**CITY OF
PARRAMATTA**

COUNCIL ASSESSMENT REPORT

DA Number	DA/436/2016/I
Proposed Development	Section 4.55 (2) modification to an approved mixed use development comprising the increase of the maximum building height from 164.10 RL to 170.40 RL resulting from the reconfiguration of the rooftop level to include solar panels, a goods lift and access stair overrun, a building maintenance unit and additional rooftop equipment. The application is to be determined by the Sydney Central City Planning Panel (SCCPP).
Street Address	4 Parramatta Square, PARRAMATTA NSW 2150 (Lot 1 DP 1234735) 6 Parramatta Square, PARRAMATTA NSW 2150 (Lot 2 DP 1234735, Lot 3 DP 1234735) 7 Parramatta Square, PARRAMATTA NSW 2150 (Lot 4 DP 1234735) 21R Darcy Street, PARRAMATTA NSW 2150 (Lot 5 DP 1234735 & Lot 3 DP 1158833)
Applicant	Walker Parramatta Square Developments Pty Ltd
Owner(s)	Parramatta Square Property No. 6 Pty Limited Parramatta Square Property No. 4 Pty Limited City of Parramatta Council

Report prepared by	Ferdinando Macri DA Planner, City Significant Development
Report date	27/02/2019

Figure 2: Proposed Roof top configuration.

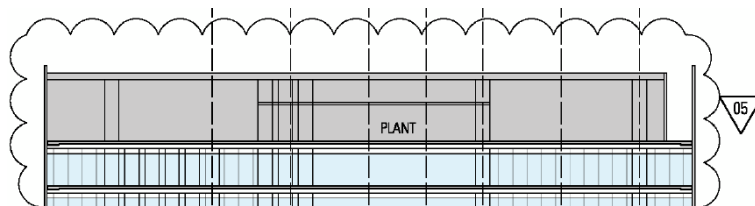
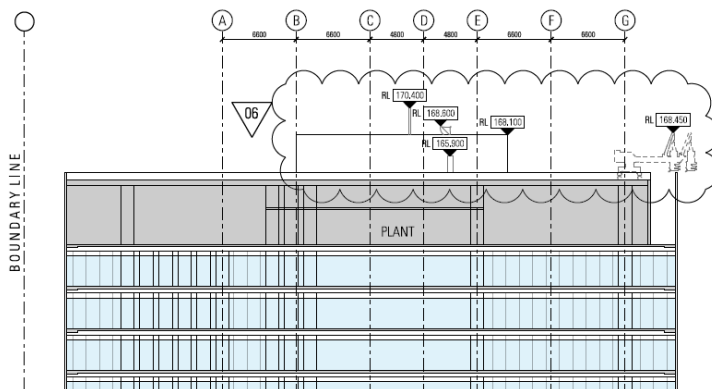
The proposed increase to the building height of 4 Parramatta Square will enable the accommodation of additional roof top safety, maintenance and plant equipment. The goods lift overrun has also been extended to enable access to service the Level 34 Plant facilities and the equipment proposed for the rooftop.

These changes have been proposed as a result of detailed design development to address tenant requirements, BCA compliance and a safety review undertaken by specialist contractors. The amendments will also meet compliance requirements of approved consent conditions and the those imposed under the airspace controlled activity approval.

- The proposed new maximum building height of 159.75 metres remains below the Parramatta LEP 200 metre height maximum.
- The height alterations are not visible from pedestrian eye level, given there is no change to the parapet height of 164.10 RL and the building elements that result in additional heights are setback from the parapet as demonstrated in the submitted perspective images. As the changes proposed are not a visible component of the façade presentation potential concerns in relation to Design Excellence are mitigated.

- The submitted shadow diagrams demonstrate that with the exception of minor impacts generated by the building maintenance unit extending beyond the building envelope when in use, shadowing from the proposed amendments are predominantly contained within the roof extent.

The proposal for a minor height increase can be supported for the abovementioned reasons.
